**Subject: Parker Street (North)
Definitive Subdivision Revision 1**

GRAZ Engineering, L.L.C. (GRAZ) has received and reviewed the following letters regarding technical review and comments of the proposed Parker Street (North) Definitive Subdivision to be located off Pine Street.

***Proposed
PARKER STREET
DEFINITIVE SUBDIVISION***

PARKER STREET (NORTH) - DEFINITIVE SUBDIVISION
LEICESTER, MASSACHUSETTS
POST DEVELOPMENT WATERSHED PLAN
PREPARED FOR: SCHOLD DEVELOPMENT, LLC (OWNER/APPLICANT)
77 CHICKERING ROAD, SPENCER, MA 01562

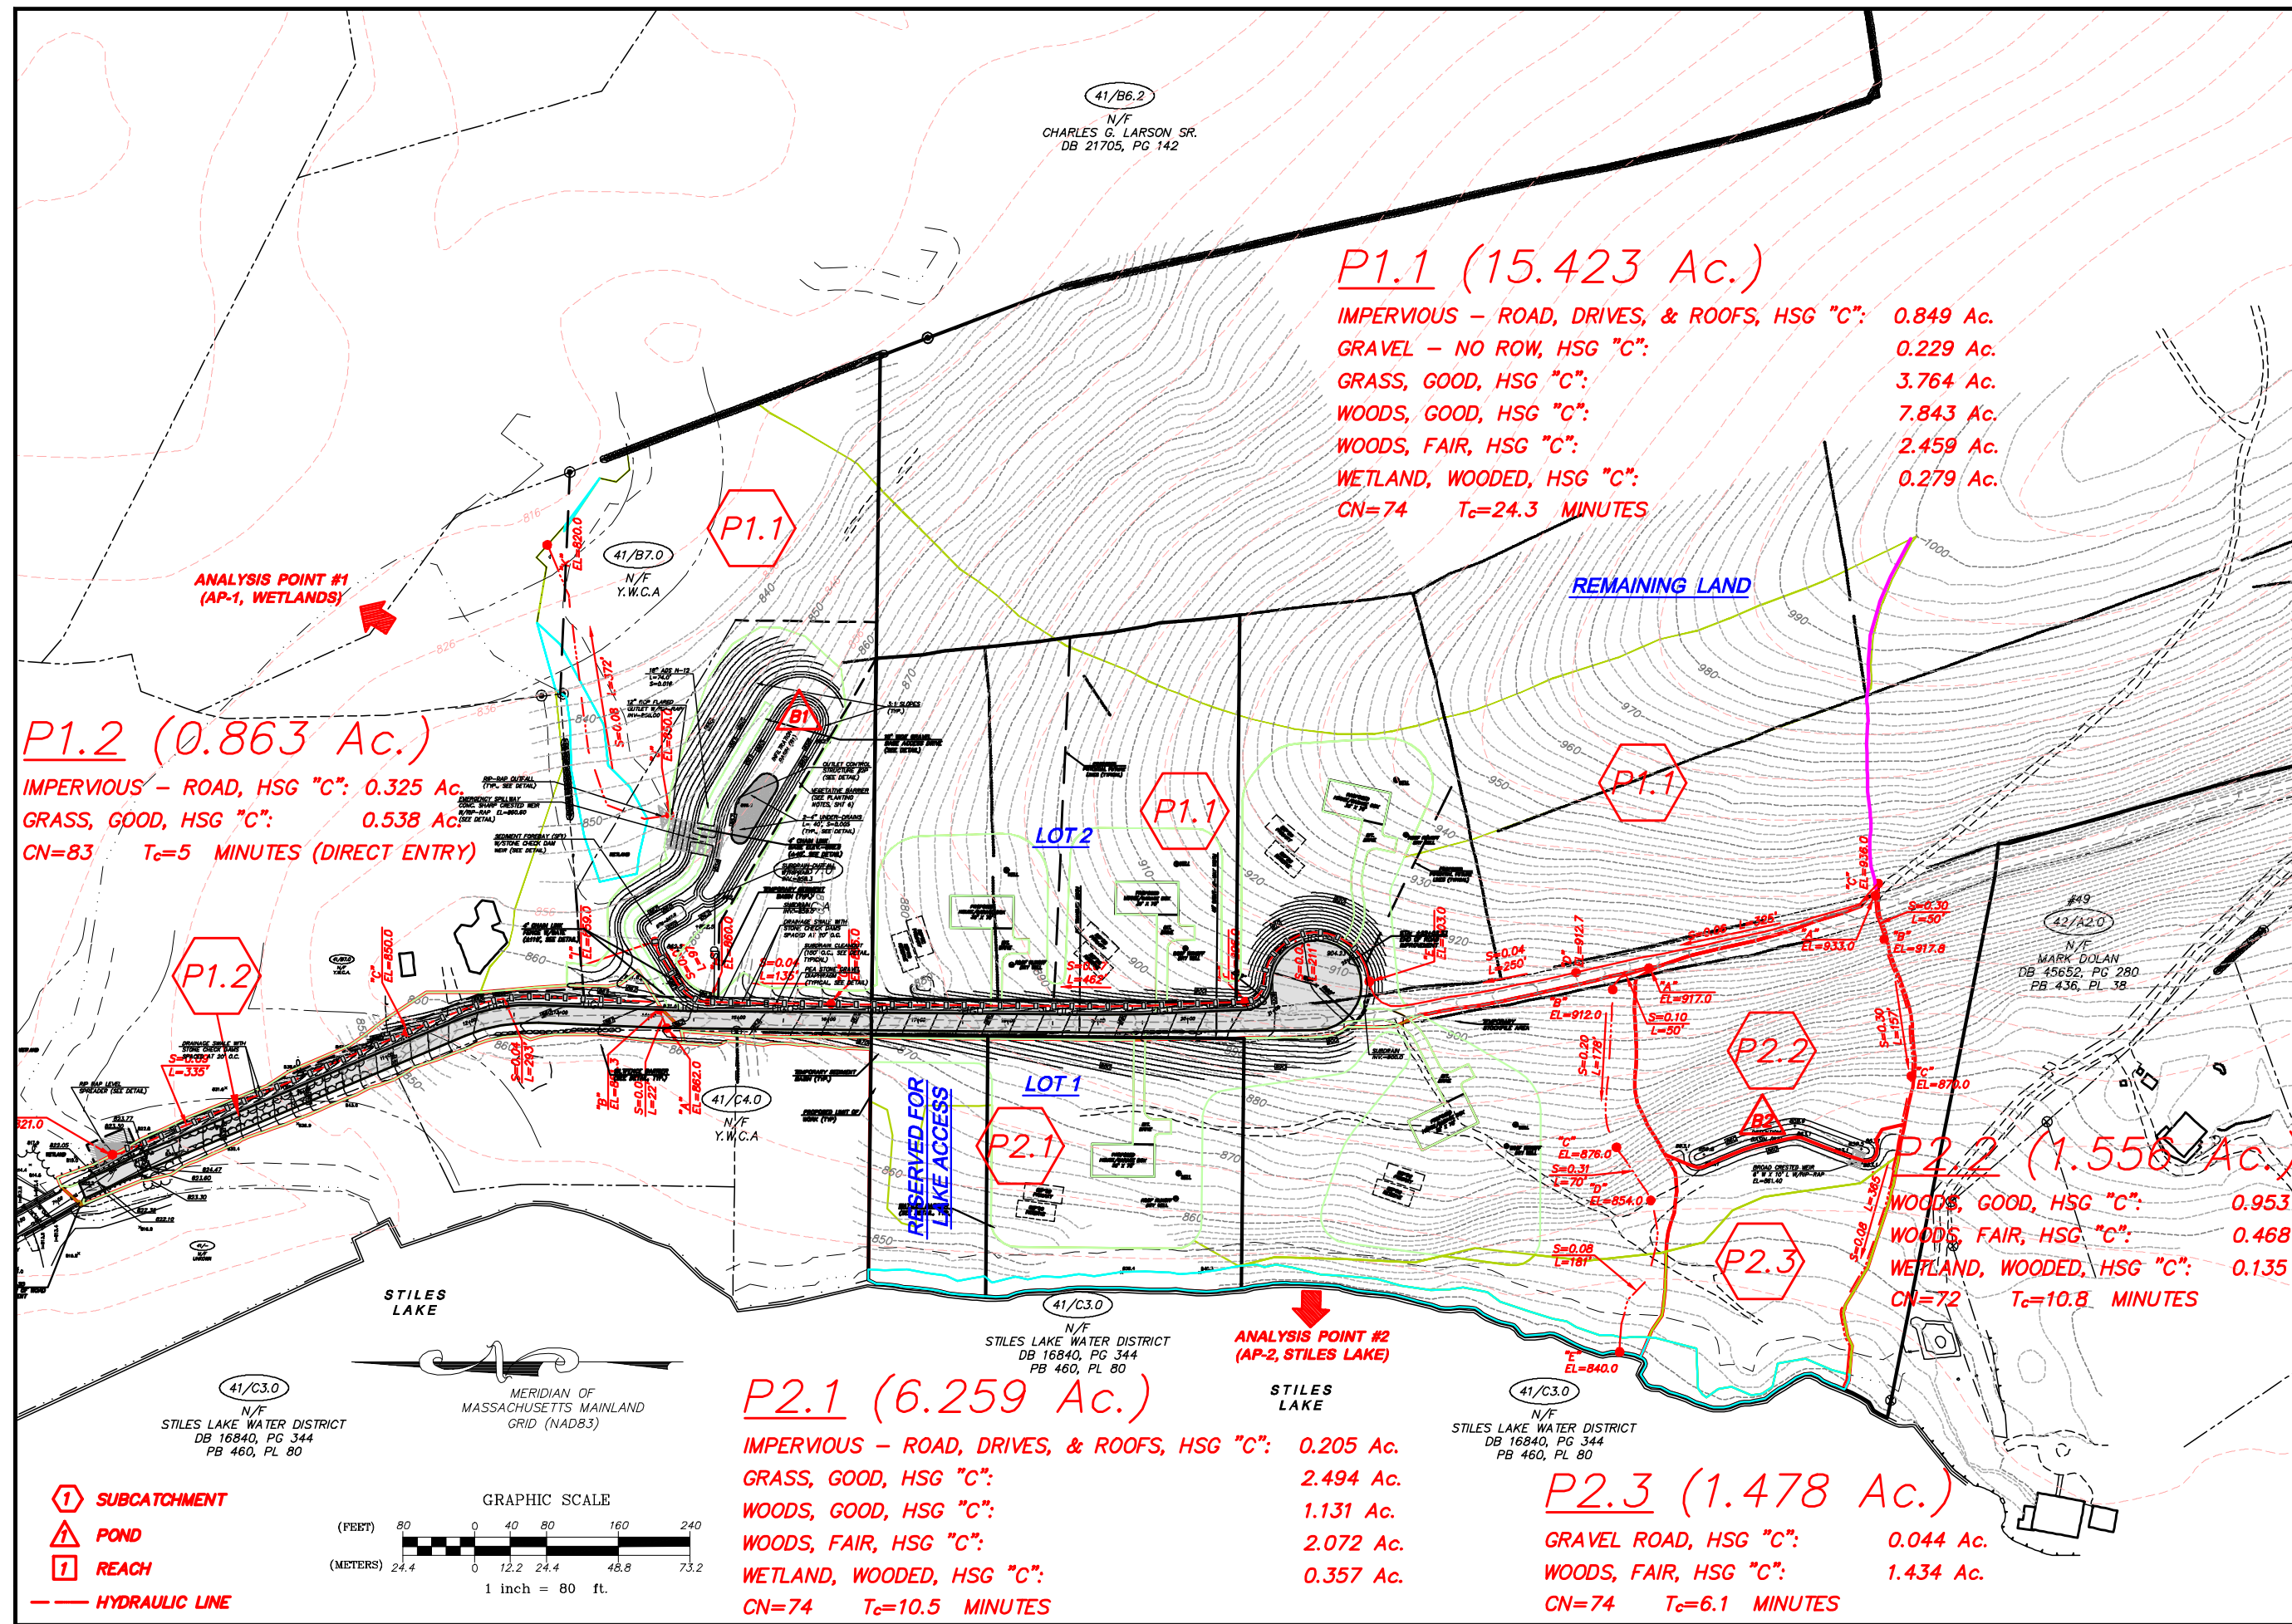
4. *The Hydrology and Stormwater Report should provide a topographic plan which outlines subcatchment areas, design points, and runoff flow routes for both the pre-development model and post-development model. We cannot evaluate the stormwater analysis in the absence of this information.*

The Hydrology Report has been revised to include the pre & post development watershed plans complete with existing and proposed topography accordingly.

SHEET 3 OF 8
REGISTRY SHEET 3 OF 3

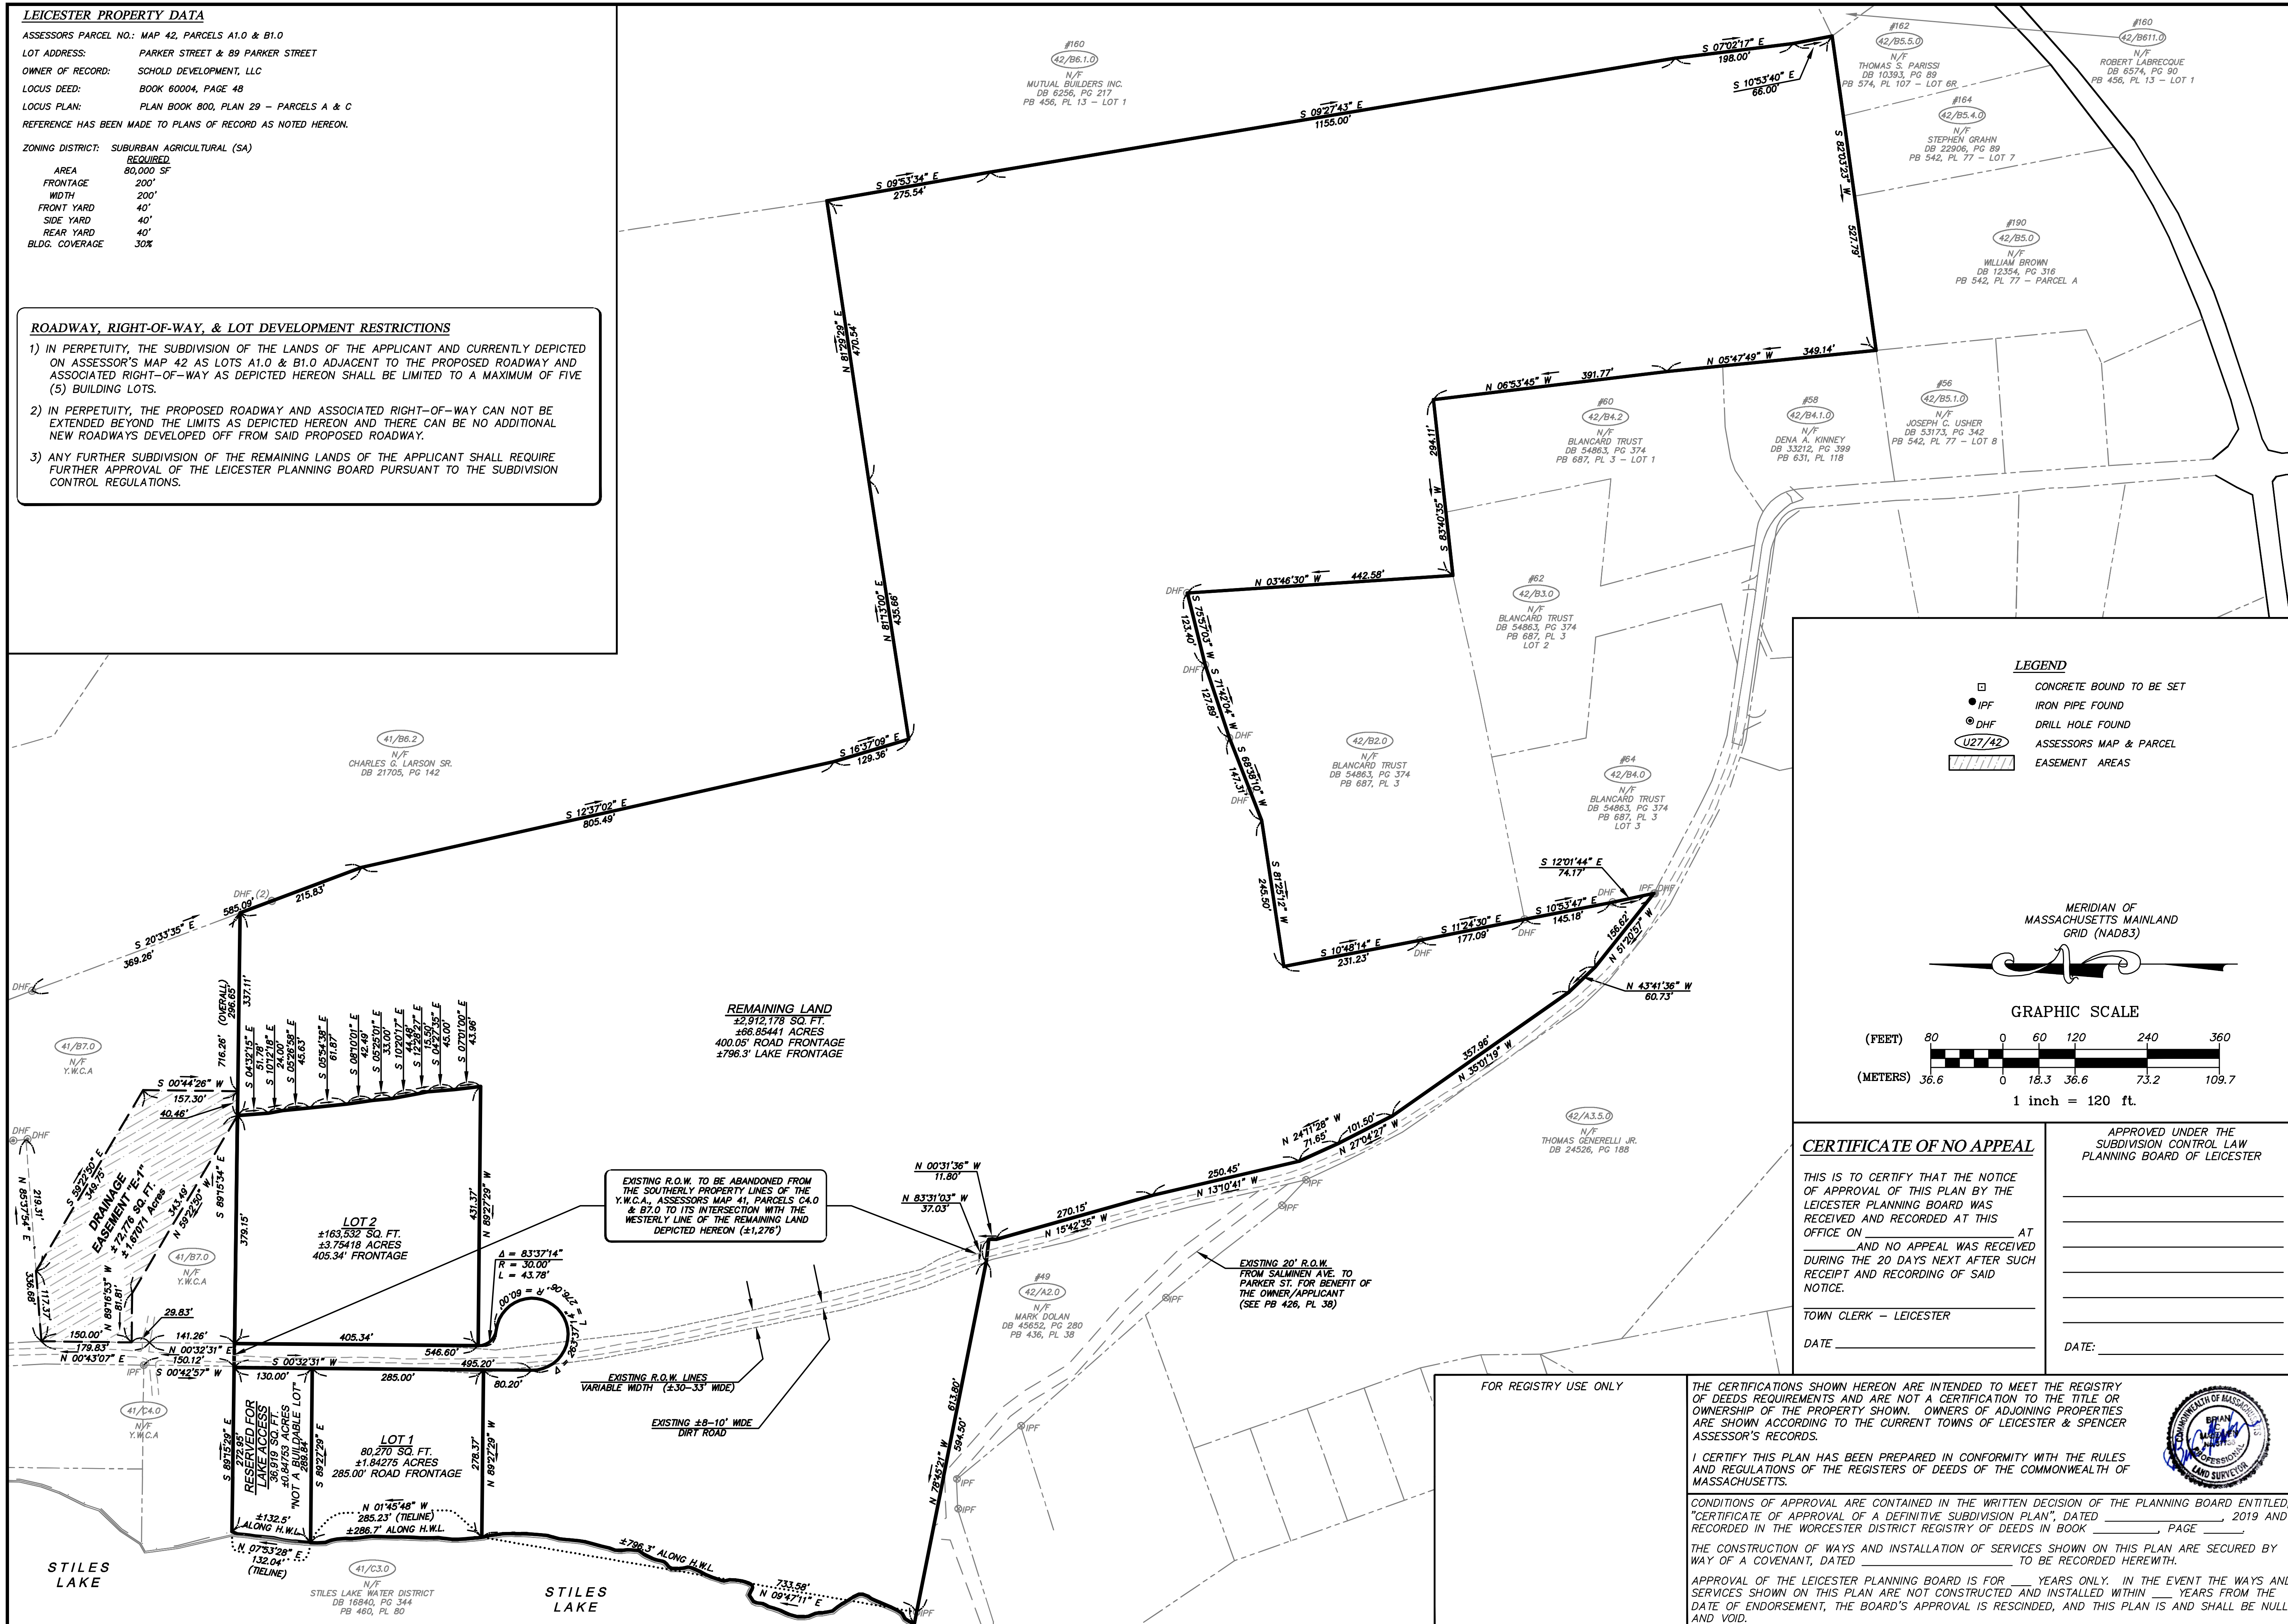
5. *The Definitive Plan application shall include proposed deed restrictions or other options to limit development in perpetuity so that the total number of lots served by the new roadway shall not exceed five (5), and to prohibit any further extension of (or new roadways off of) the Parker Street extension proposed by this application. What is proposed to limit development?*

Sheet 3 of the plans has been revised to include notations as to what the Applicant understands to be the minimum restrictions for the build-out of the lands that is being developed under this project. These notes are as follows:

- **In perpetuity, the subdivision of the lands of the applicant and currently depicted on Assessor's Map 42 as lots A1.0 & B1.0 adjacent to the proposed roadway and associated right-of-way as depicted hereon shall be limited to a maximum of five (5) building lots.**
- **In perpetuity, the proposed roadway and associated right-of-way cannot be extended beyond the limits as depicted hereon and there can be no additional new roadways developed off from said proposed roadway.**
- **any further subdivision of the remaining lands of the applicant shall require further approval of the Leicester planning board pursuant to the subdivision control regulations.**

STORMWATER BASIN CROSS SECTION
N.T.S.

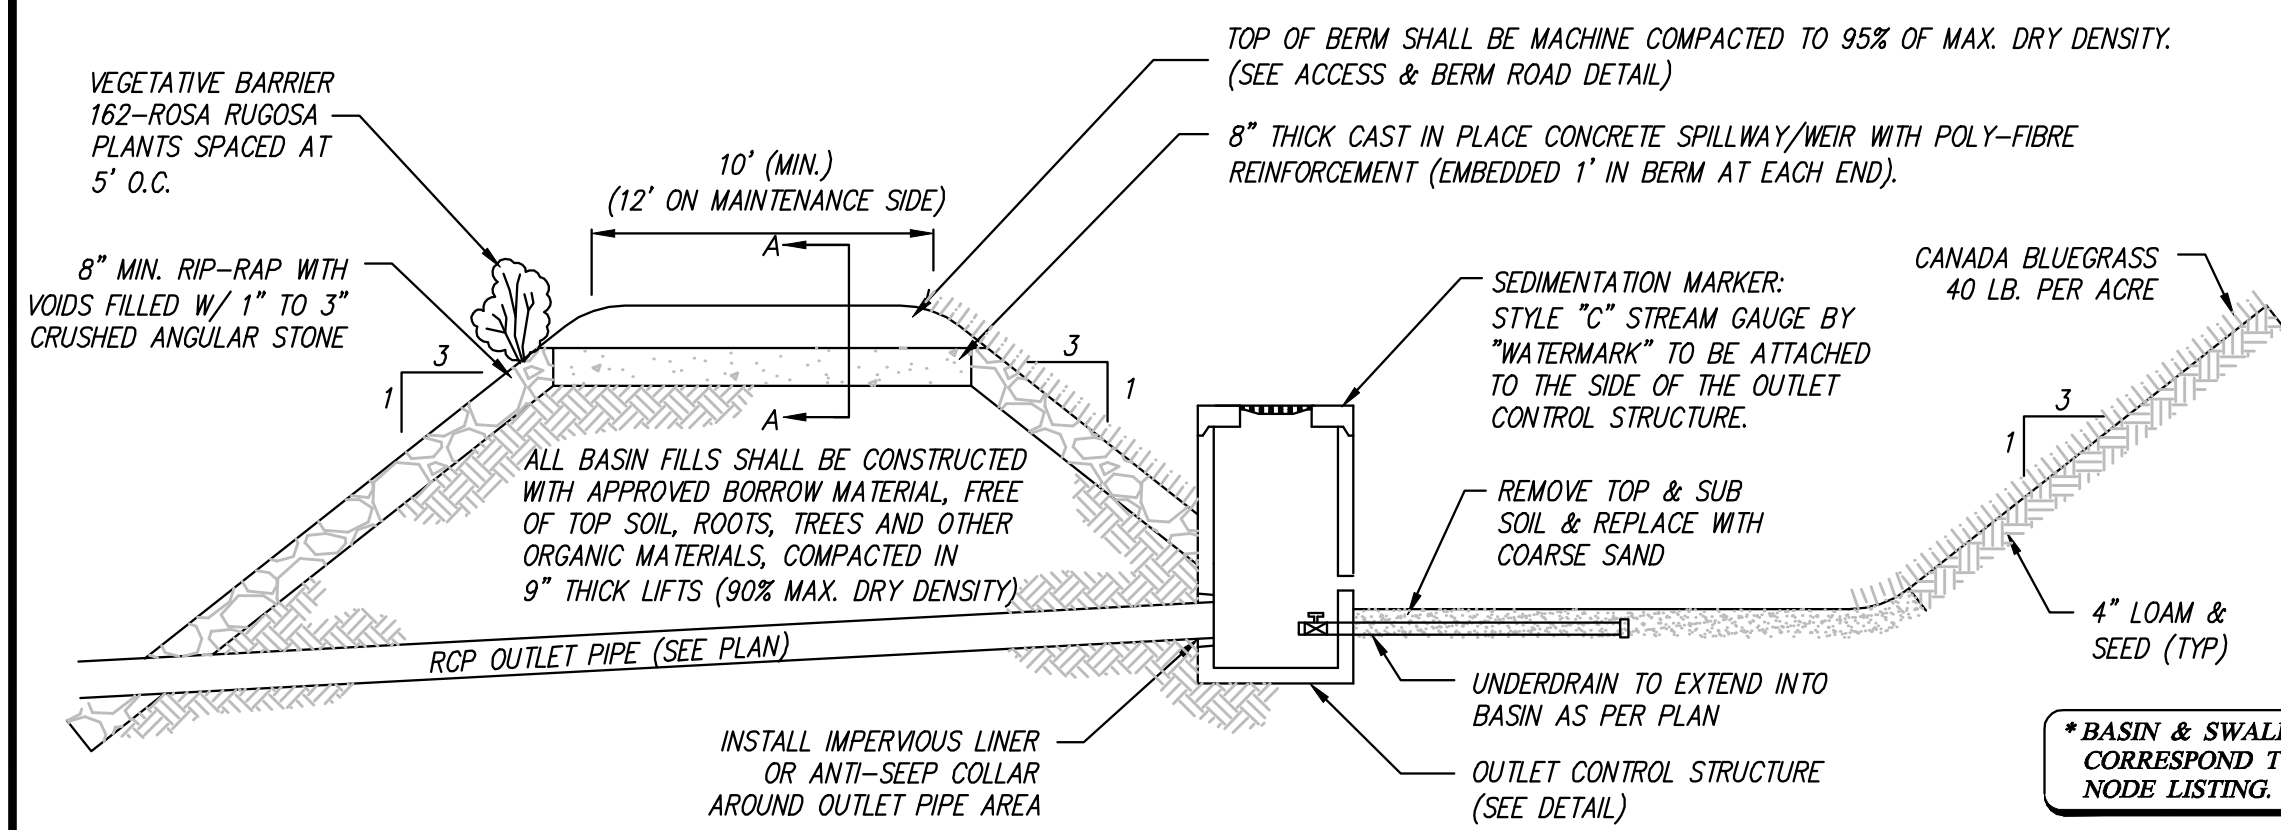
7. *The Stormwater Basin Cross Section, Sheet 8 of 8, calls for planting a row of thorny rose bushes ("Rosa Rugosa") along the outside crest of the stormwater basin berm (Infiltration Basin #2P), as a deterrent to entry. The roses cannot be planted on either the gravel access road, nor the Emergency Spillway. Some other means of restricting access over those areas must be developed.*

The plans have been revised to depicted two (2) means of entry deterrent to the stormwater basin (B1). Chain link fencing will be used at the entry point with the proposed roadway as well as across the top of the basin spillway weir. The remainder of the perimeter shall have the "Rosa Rugosa" plantings installed as depicted on the plans accordingly.

SUBDRAIN DETAIL
N.T.S.

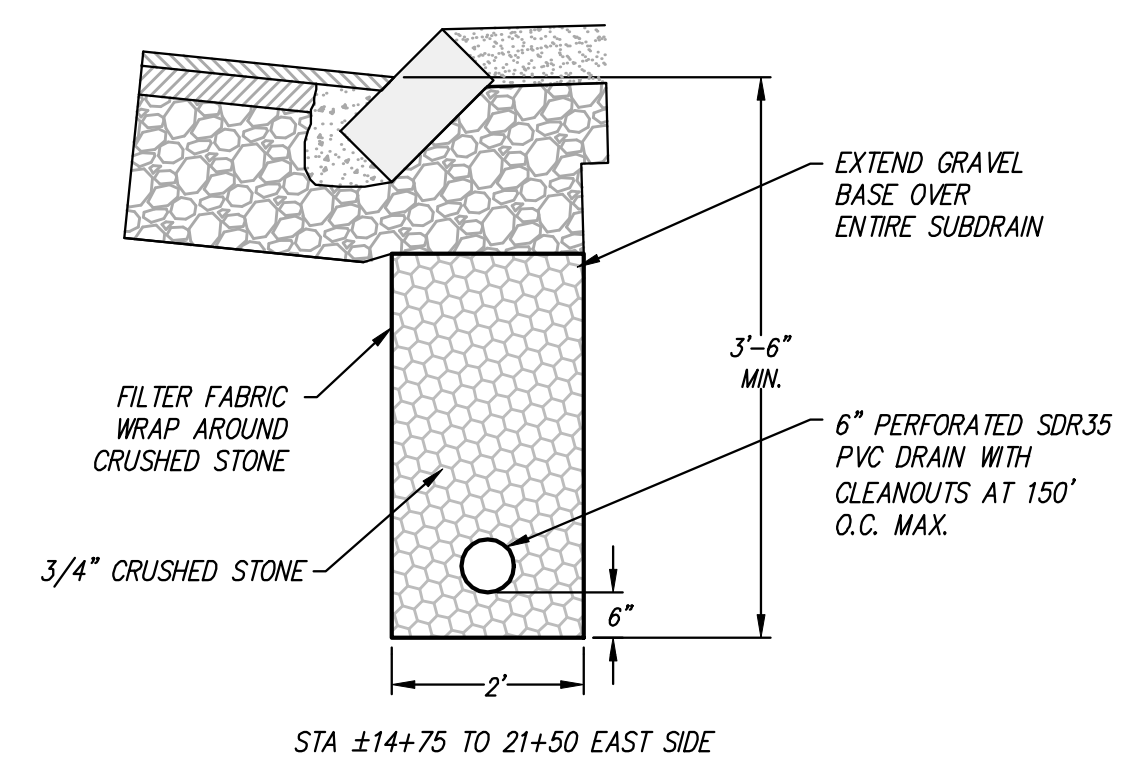
1. *The proposed cul-de-sac cuts into a hillside grade, in an area where groundwater appears to be active. A sub-drain must be called out around the cul-de-sac in all cut areas, to control and remove groundwater from the base gravel.*

The plans have been revised to depict the locations, elevations, and details of the proposed sub-drain accordingly.
